MESHESAT-1357, stream a1mech, 29 Sep 2026. Case frame: X east, Y toward the hinge (back) wall, Z up from the base floor, lid closed. mm. Prototype design, AI review: nothing built, bought or fitted; analytical success is not physical verification.

MeshSat field kit V2, Option A(i) lid pack: sheet A1-2 sections: the module under the ceiling over the face, at the worst room

MeshSat field kit V2, Option A(i) lid pack: sheet A1-3 the arrangements that fit, and the owner decision

MeshSat field kit V2, Option A(i) lid pack: sheet A1-6 the base pockets: section 8's 4S6P at the same worst figures

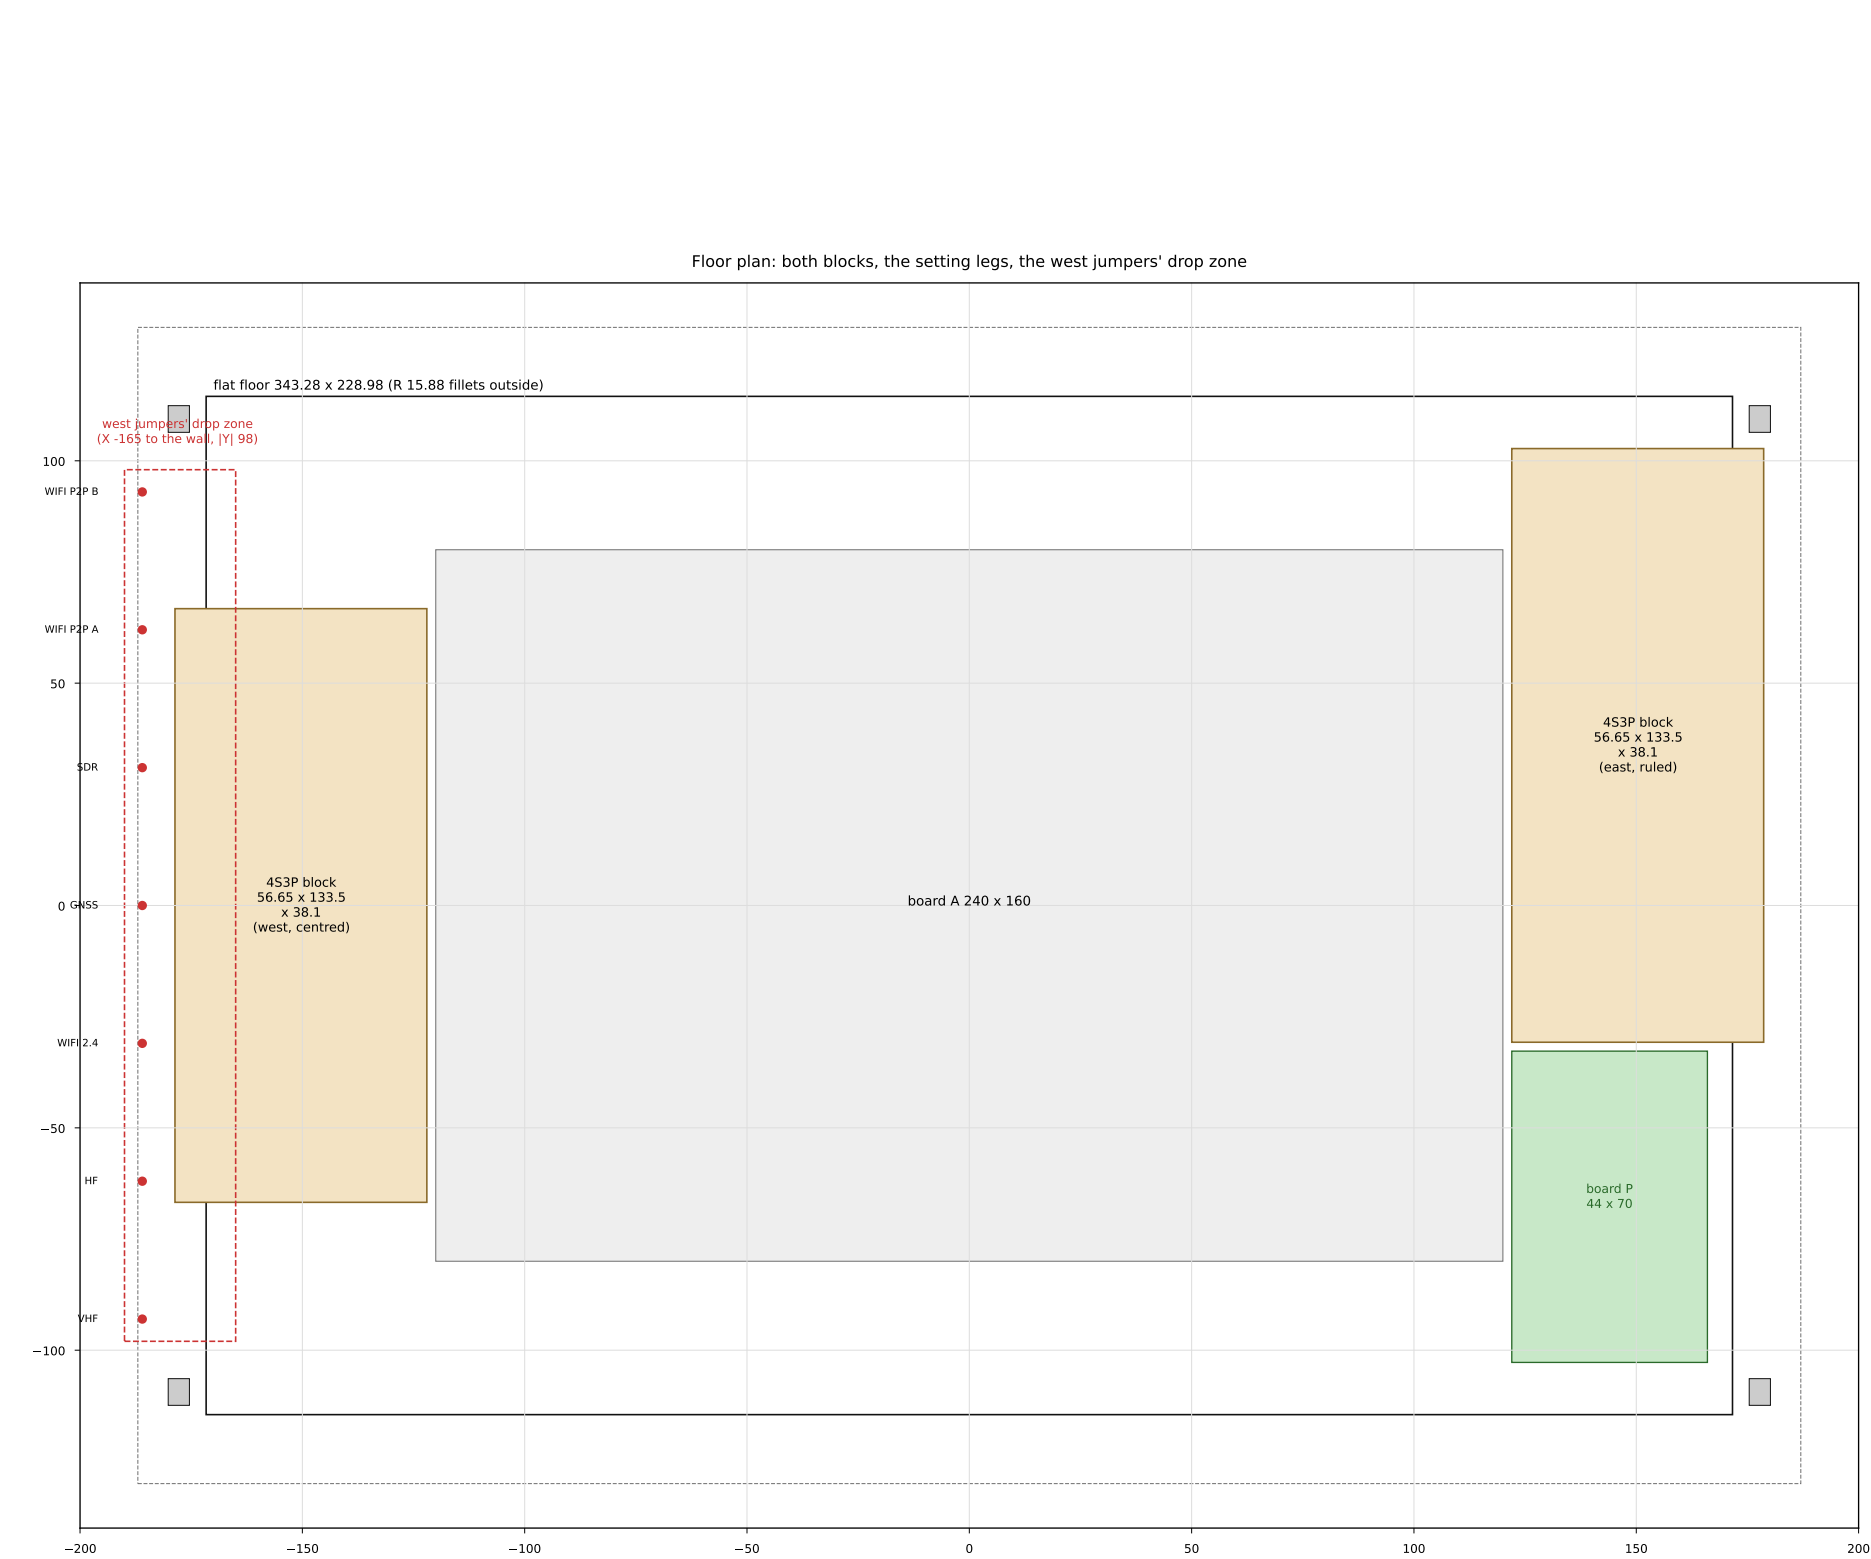
ROW	worst	x2	verdict
M4a	1.85	0.85	OPEN: placed by hand; T4
M4aw	1.85	0.85	OPEN: placed by hand; T4 (mirror: Peli's cavity and
M4b	7.38	6.38	MET
M4bw	7.38	6.38	MET (mirror: Peli's cavity and the RF entry plates a
M4c	3.18	1.80	MET
M4cw	3.18	1.80	MET (mirror: Peli's cavity and the RF entry plates a
M5	1.77	0.27	OPEN: placed by hand, the legs' locator; T4
M5w	37.77	36.89	MET (the block's Y place is not ruled; centred here)
M6	3.66	2.90	MET
M6w	3.99	n/a	OPEN: the x2 reading is not computed by A06's tool;

WEST RF JUMPERS: 5 of 7 west cables (Y -62, -31, 0, 31, 62) fall onto the west block; the slot over it is 7.19 at the worst less C33's zone (3.99); the only drop east of it is its 2.0 gap to board A, under one RG-316 (2.49): FAILS AS ASSUMED, held OPEN (section 8b, the M17 class): the west RF entry is re-planned before the west block is taken. Hold-down S-27 open for both blocks.
